## TOWN OF FORT MILL PLANNING COMMISSION MEETING

December 16, 2015  
112 Confederate Street  
7:00 PM

**Commercial Appearance Review: QuikTrip**

Request from QuikTrip for a preliminary review of a proposed gas station/convenience store located at the corner of Highway 160 and Springfield Parkway.

REV	DATE	DESCRIPTION										ORIGINAL ISSUE DATE: 12/01/2015
REV	DATE	DESCRIPTION											
SHEET TITLE: <b>SITE/DEMO PLAN</b>													
SHEET NUMBER: <h1 style="margin: 0;">1</h1>

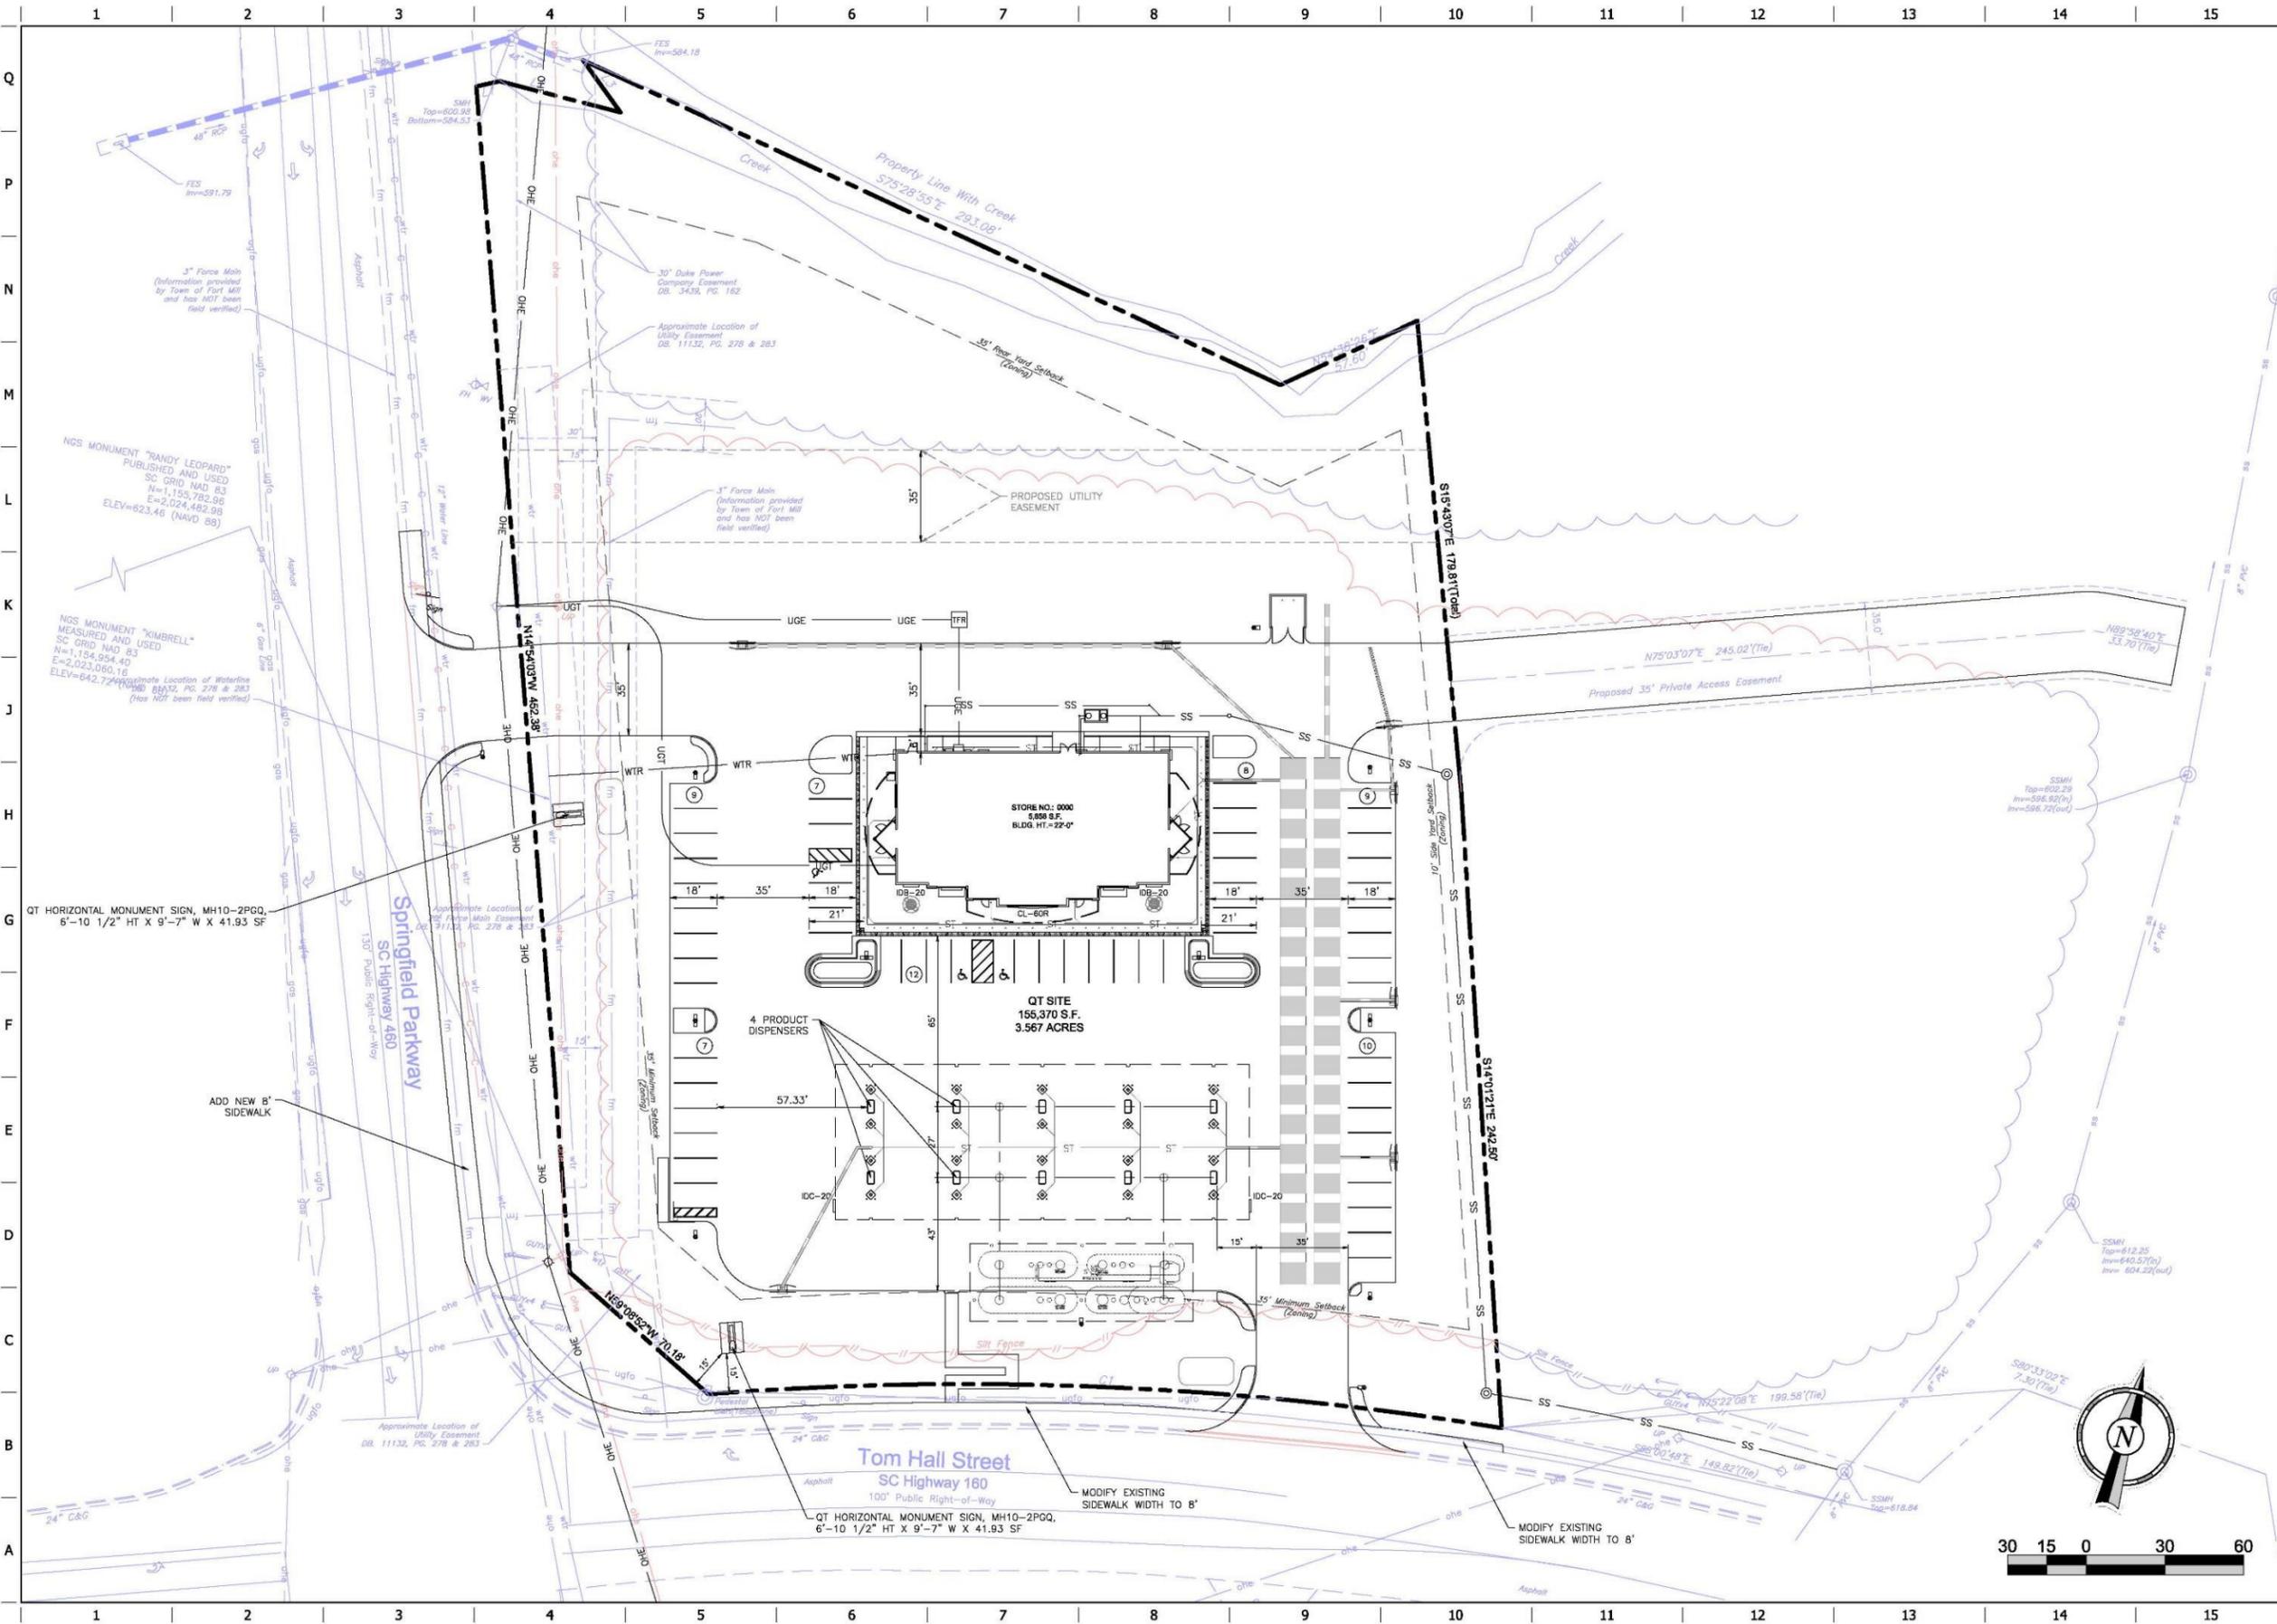
A lighting plan would be required for the project, however one was not provided with the submission. The COD-N overlay notes that "Lighting shall be installed within the streetscape zone (the first 15 feet of the setback closest to the corridor)" in accordance with a master plan for the corridor, if it exists. The purpose of the lighting would be to provide a safe pedestrian realm. The Town hasn't adopted a master lighting plan for the corridor, so a discussion will need to occur to set the tone for this area of the corridor. Lighting within the interior of the project would need to be a maximum of 28' in height.

An 8' pathway is required along the frontages of Springfield Parkway and Highway 160. The COD-N overlay notes that the pathway shall be no closer than 8' to the edge of pavement of the adjacent streets, in an attempt to bring the pedestrians away from traffic to create a safer pedestrian realm. The applicant shows an 8' path directly beside the edge of pavement for the streets. The Planning Commission, at their discretion, would need to approve this deviation using the procedure noted in Subsection 17 "Alternative means of compliance" within the COD-N overlay code. Staff will note that the pedestrian pathway adjacent to the road already exists along Highway 160.

In relation to driveways, the COD-N overlay code notes that no driveway shall be allowed within 400 feet of an intersection of any other public road on the corridor. The driveway shown appears to be generally in compliance with that requirement. Further development on the subject parcel could utilize the driveway as planned on the attached site plan, and the development plans as proposed do not block the possibility of future inter-parcel connectivity. Staff will note that the adjacent parcel along Springfield Parkway would not be required to follow the same access management regulations since it is not located within the COD-N overlay.

Parking, as shown on the attached site plan, exceeds the requirements of the zoning ordinance. As mentioned previously, the parking is to be located to the side or rear of the structure(s) to the extent practical. The Planning Commission, at their discretion, shall determine whether the proposed design meets the requirements, and intent, of the COD-N overlay district.

A key to the overlay requirements is to create a pedestrian/bicycle friendly environment. As such, the overlay requires that bicycle parking be present in addition to vehicular parking. A minimum of 2 "spaces" would be required for the convenience store. The current plan does not show bicycle parking.

SHEET TITLE:  
LANDSCAPE PLAN

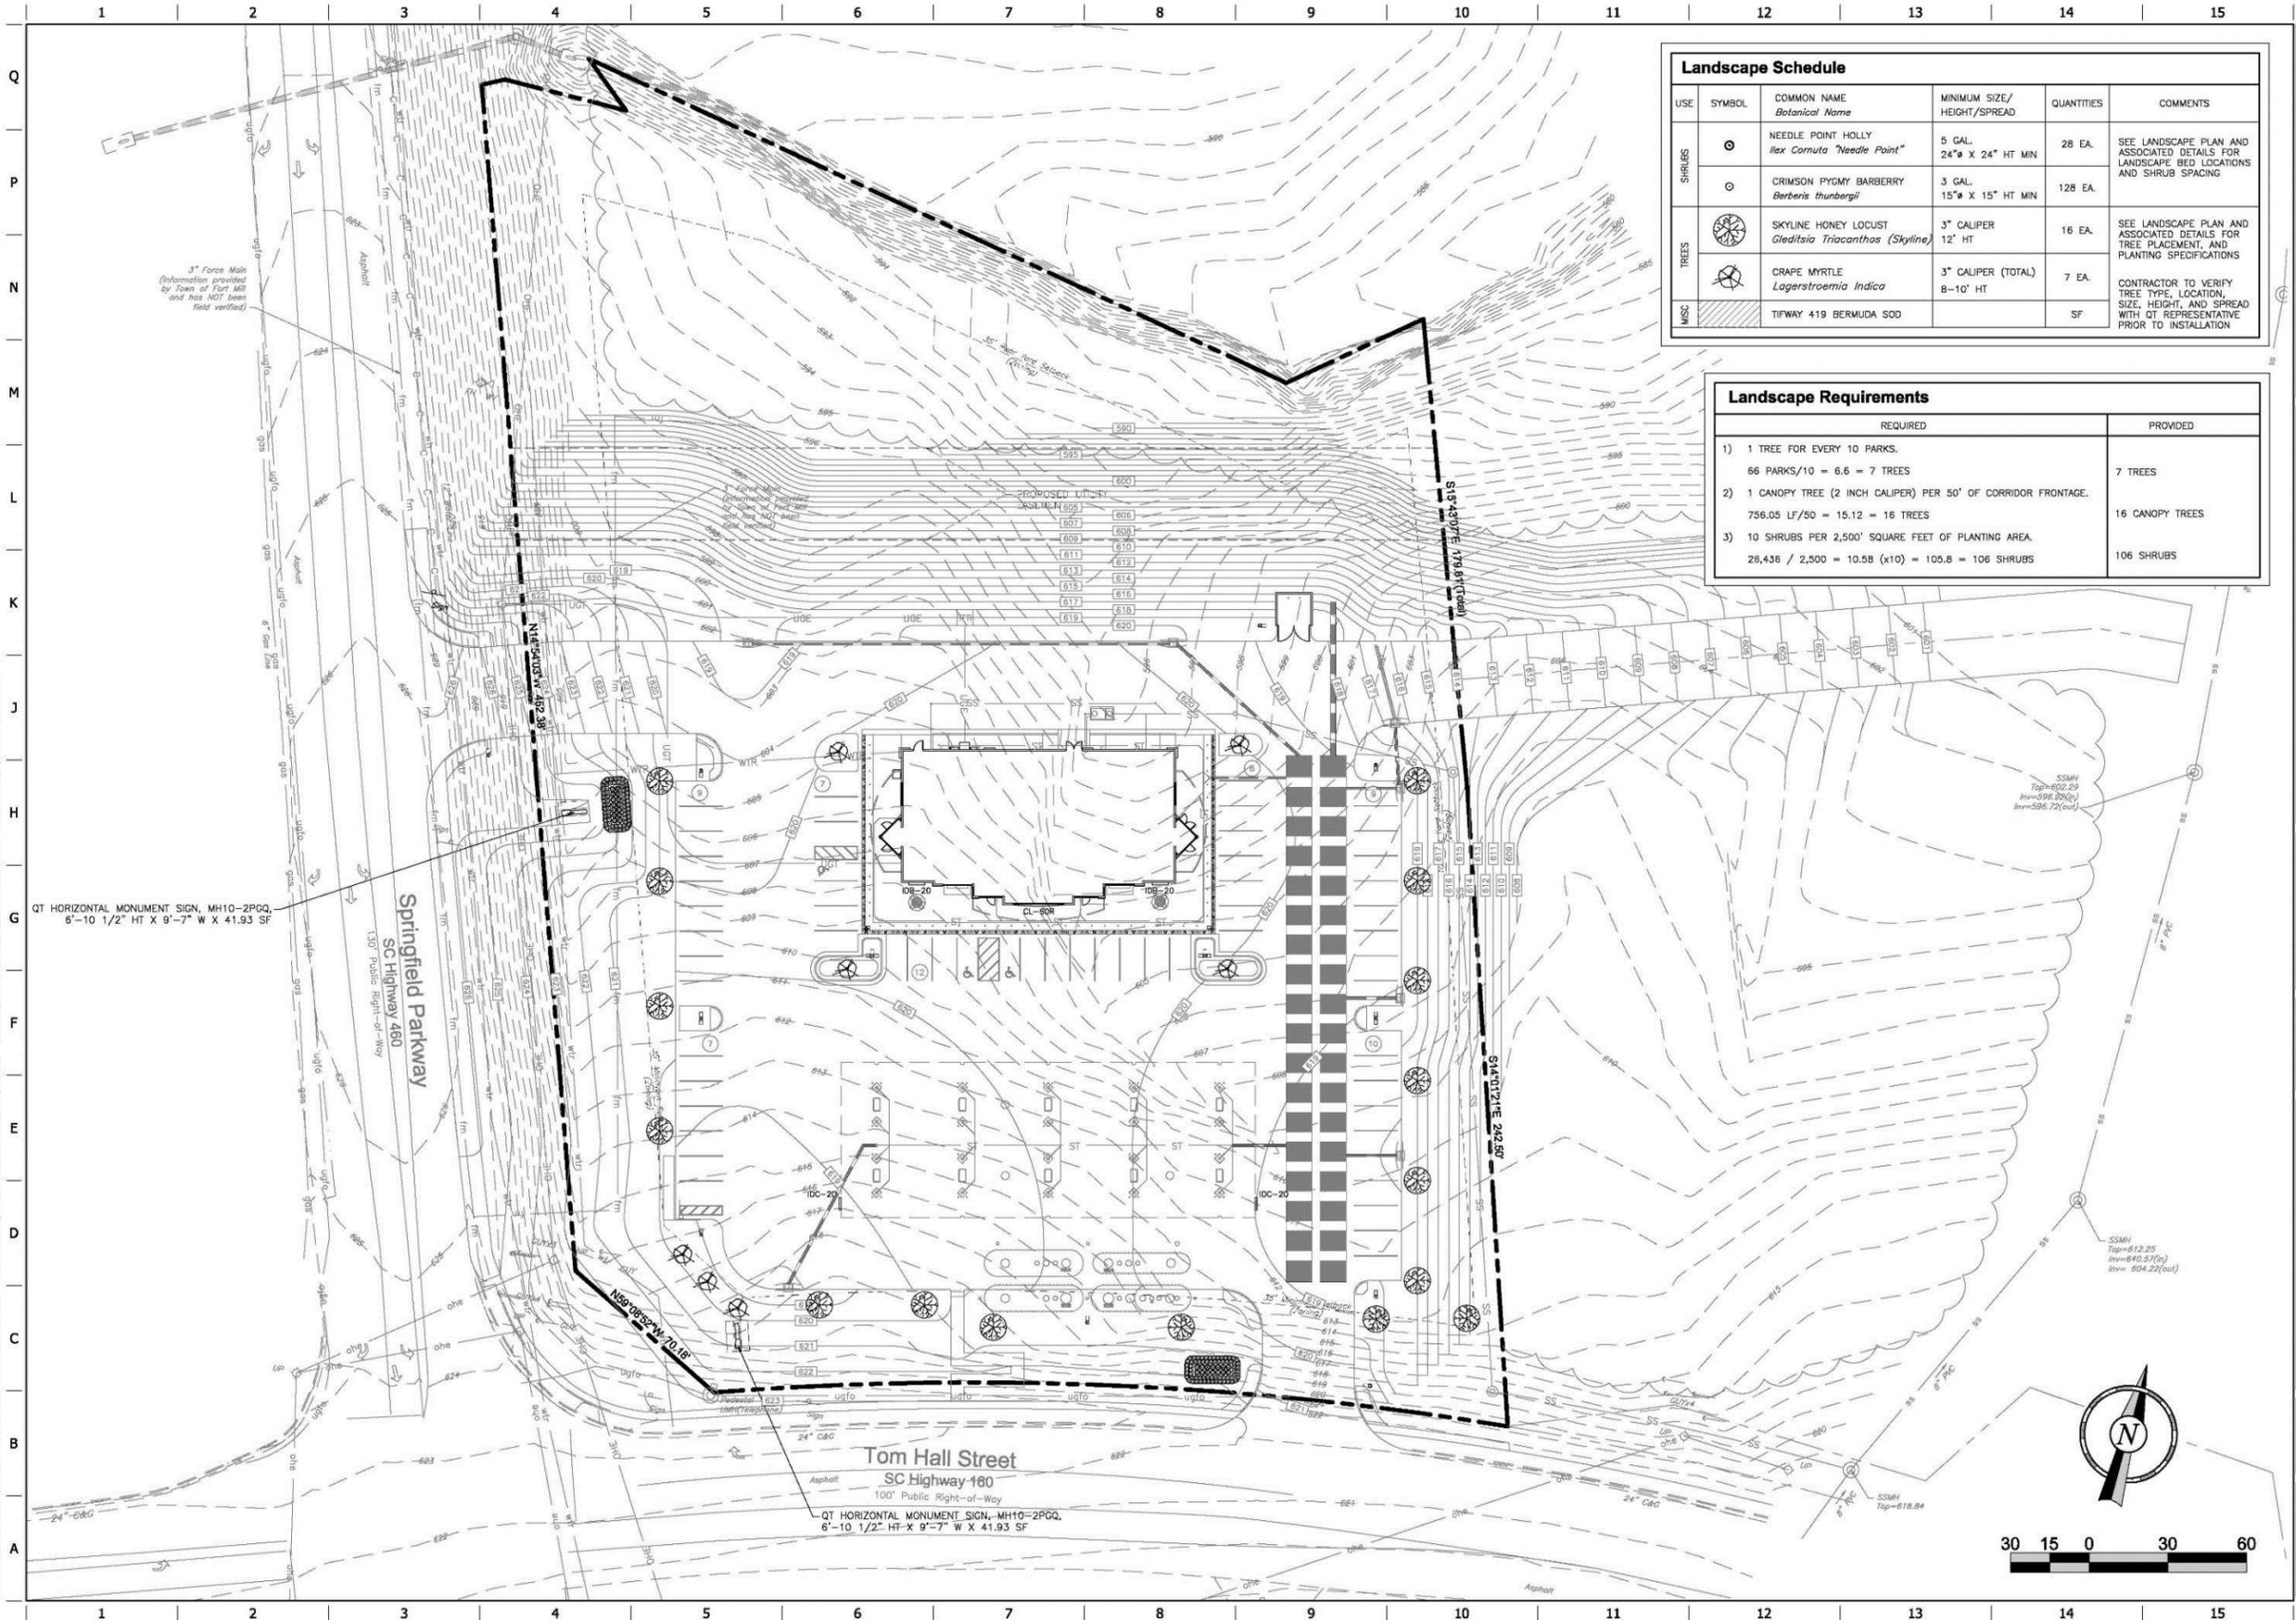
The applicant has supplied a landscape plan showing a mixture of crape myrtle and skyline honeylocust trees within the parking lot and along the project perimeter. Shrubbery was also included in two locations. Staff will note the following requirements of the COD-N:

1. Street trees are to be provided at a rate of one tree per 50 linear feet of frontage. In this case, the frontage would include Highway 160 as well as Springfield Parkway. The applicant has provided the appropriate number of plantings, however these plantings are to all be located within 15' of the frontage ROWs. As shown, these trees surround the entire property perimeter.

2. Additional plantings are determined by calculating the "planting area" defined in "Streetscape" section of the COD-N overlay requirements. Per staff's calculation (756.05 LF – (2)45' entrances), the following would need to be planted within 35' of the frontage ROW:

- b. 94 shrubs, with 50% being evergreen (the applicant has shown a total of 106 shrubs located in two planting areas). See bullet #4.
3. A tree survey marking significant trees to be removed/protected was not provided, therefore compliance cannot be determined. Any trees 30 inches or more in diameter that are saved shall count towards the required planting requirements. Any trees 30 inches or more in diameter that are removed shall be replaced with a 6" caliper tree of a similar species.

4. Off-street parking areas are to be screened from frontage ROWs by a minimum of one row of evergreen shrubs planted no more than 5' on center. Staff calculates a total of 133 shrubs would be required to meet this requirement. These shrubs may be used to meet the requirements listed in bullet #2(b).
